U.S. Department of the Interior BUREAU OF LAND MANAGEMENT Sundry Print Repor

Well Name: POKER LAKE UNIT Well Location: T24S / R30E / SEC 18 / County or Parish/State: EDDY /

Notice of Intent

PLUG AND ABANDON WELLBORE POKER LAKE UNIT 212 EDDY COUNTY, NEW MEXICO Class II

PLU 212 - Proposed WBD

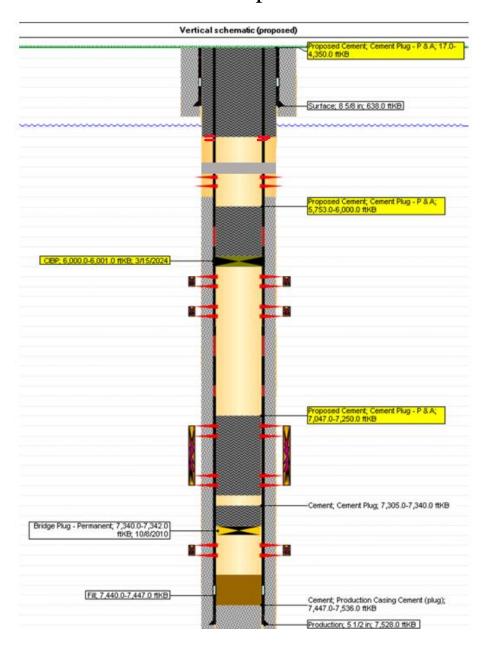
BLM Revised P&A Procedure

- 1. MIRU and set open top steel pit for Plugging
- 2. POOH rods and pump
- 3. RIH and tag CIBP at 7340'.
- 4. Spot 25 sks Cl H cmt from 7250'-7047'. WOC and Tag (T/BS)
- 5. Run CBL from 6000' to surface. Contact BLM.
- 6. Set CIBP at 6000'. Spot 25 sks Cl C from 6000' to 5733'. WOC and TAG. Pressure Test. (T/Brushy)
- 7. Pref and sqz 5600' to 5400'.
- 8. Perf and sqz 4350' to surface. (t/Delaware, T,B/Salt)
- 9. Cut casing and set Dry Hole marker
